**Draft Final Conceptual Site  
Model for the  
Yerington Mine Site**

**August 26, 2002**

**Subject: Draft Final Conceptual Site Model and Response to Comments on the  
Draft Conceptual Site Model dated June 13, 2002**

**FIGURE 3**  
**SURFACE MINE UNITS**  
YERINGTON, NEVADA

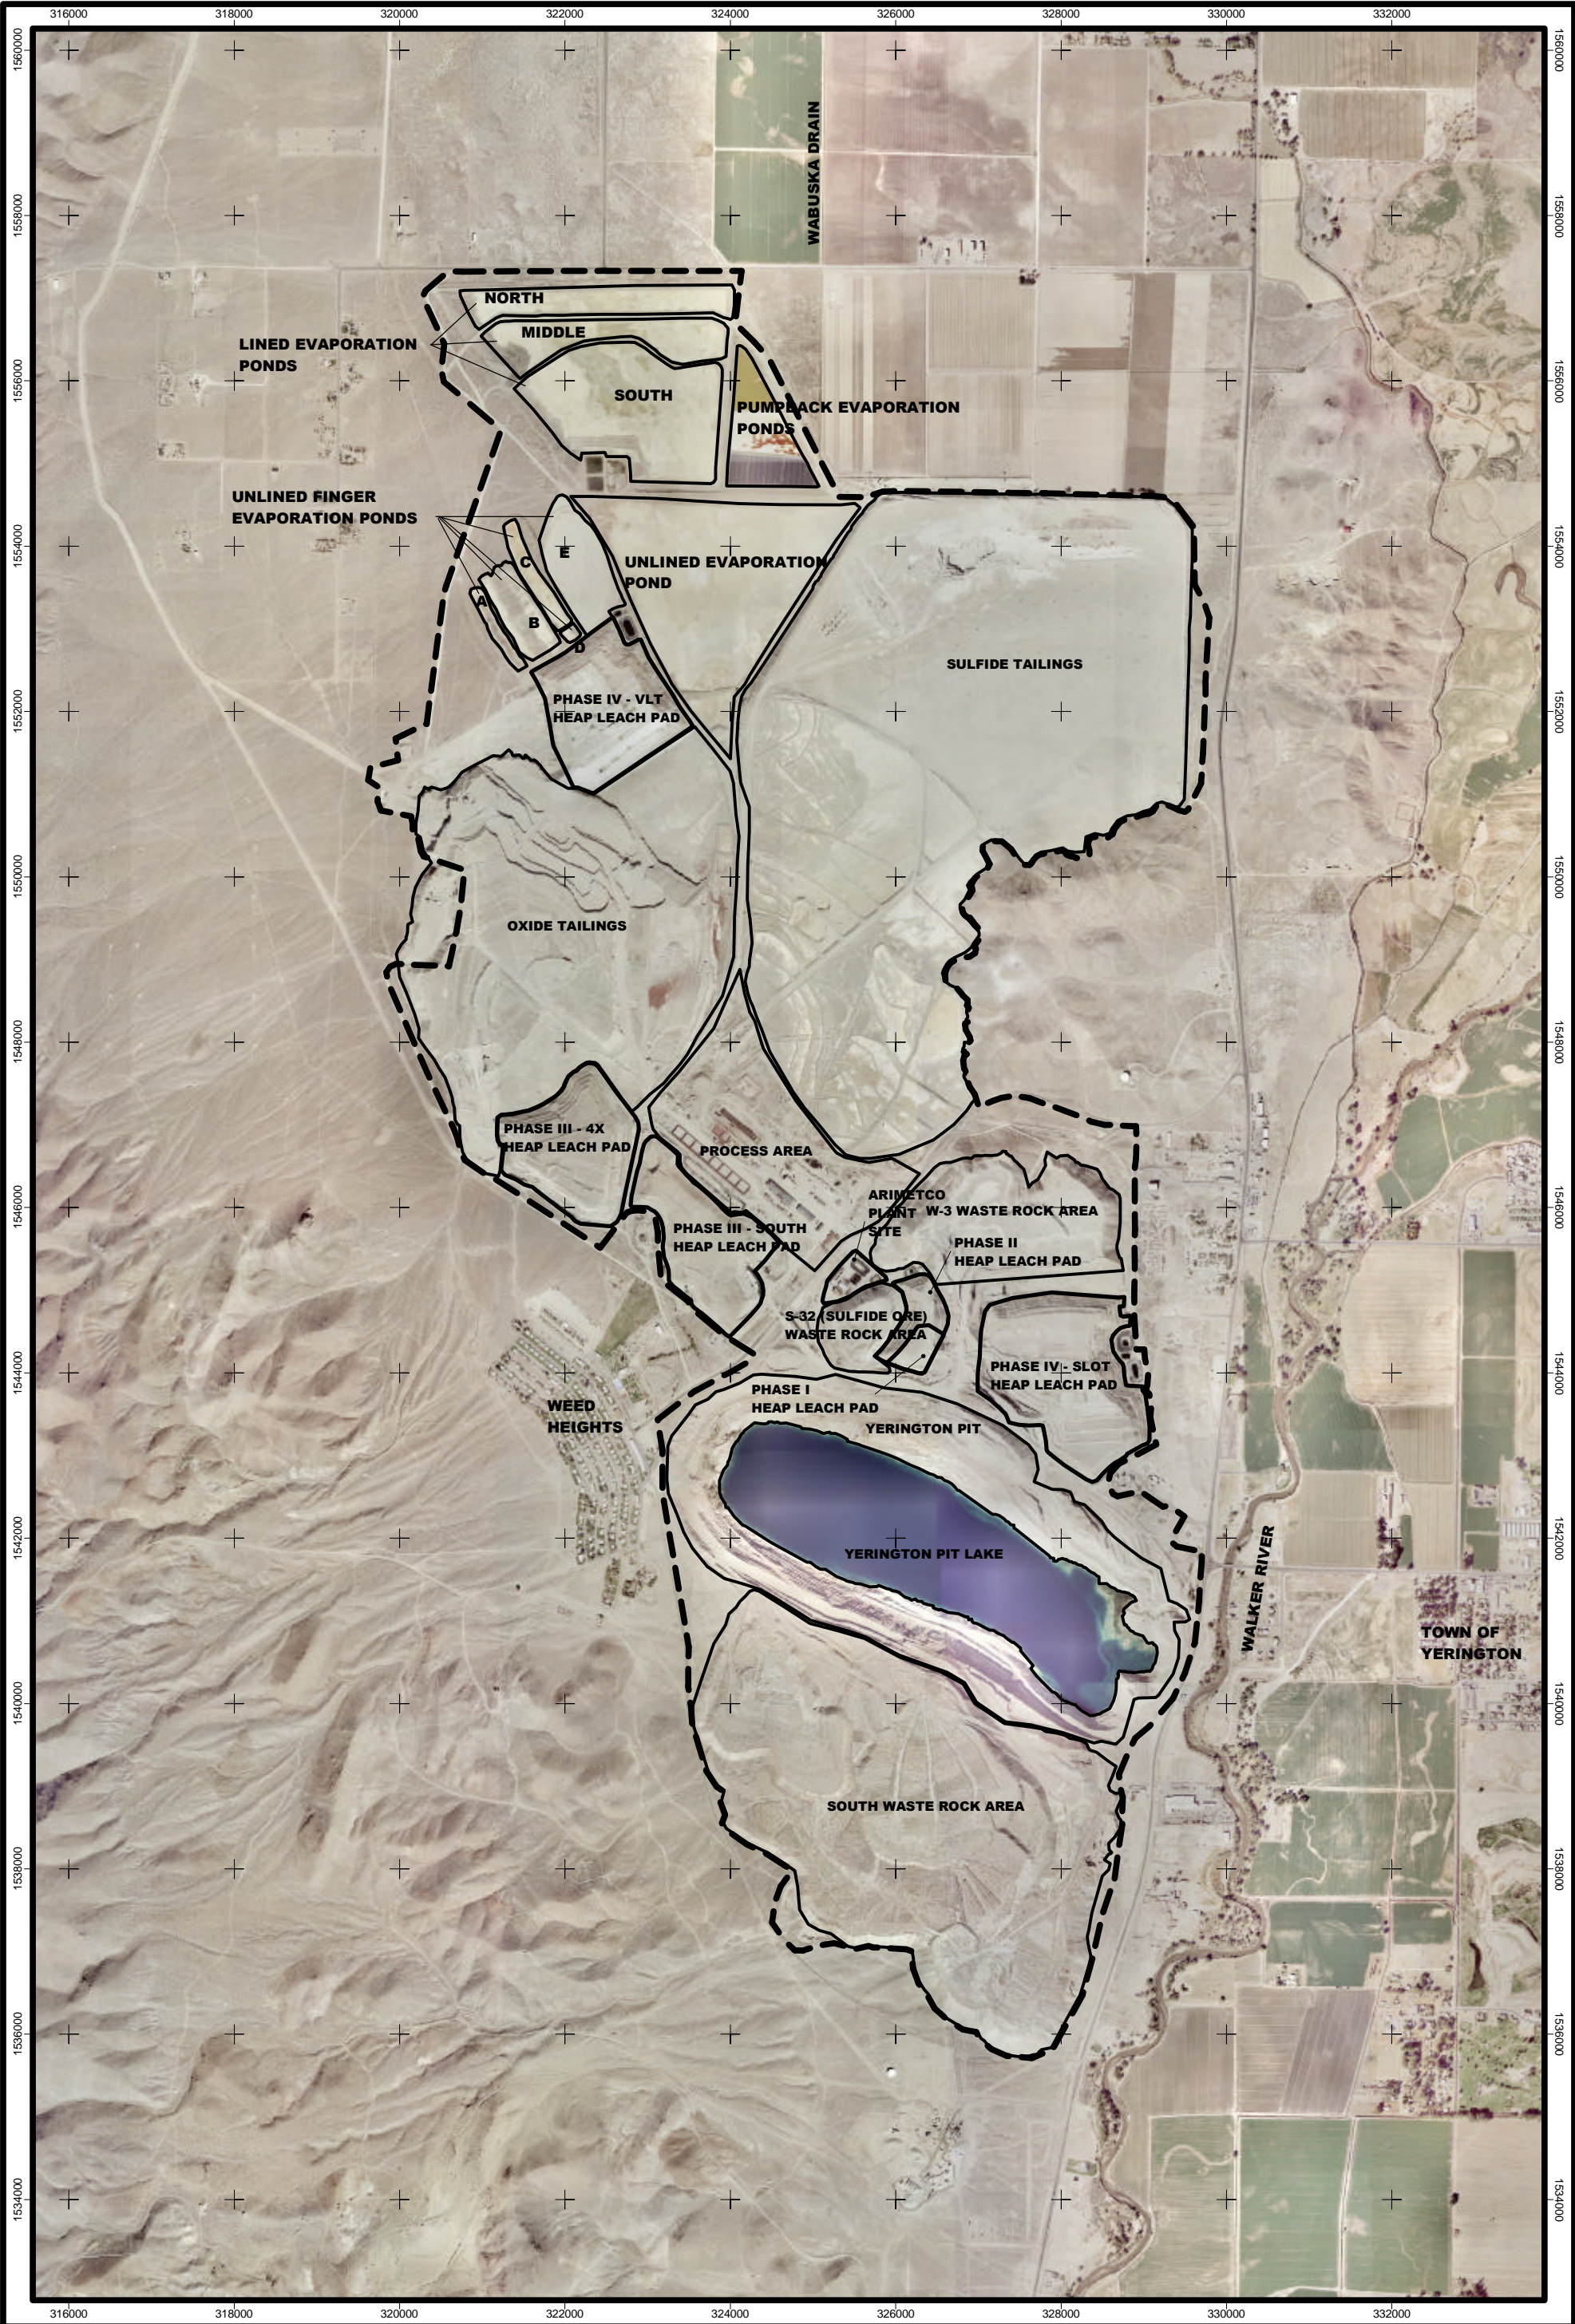
Comment no. 13: Although the focus here is on mine units, it would be helpful to label the following: Weed Heights, as it shows the proximity of humans to the site as well as showing its location; the location of Wabuska Drain, and the location of the Walker River.

Please add the Former Plant Site where Arimetco later constructed the Megapond.

It appears that the Waste Rock Area (North) was actually a low grade stockpile. It was also a former Anaconda Leach Pad and was operational for an undetermined length of time.

*Response to Comment no. 13: Weed Heights and the Walker River are now labeled on the figure. The southern portion of the Wabuska Drain will be included in the revised figure.*

*The Former Plant Site is labeled on the figure as Plant Site. The Megapond, is shown, but is not labeled only because other process ponds on the figure are not labeled. The photo would be too cluttered if all ponds were labeled.*

*This is addressed in the Waste Rock and Arimetco Heap Leach Work Plans. This level of detail is not intended for the CSM.*
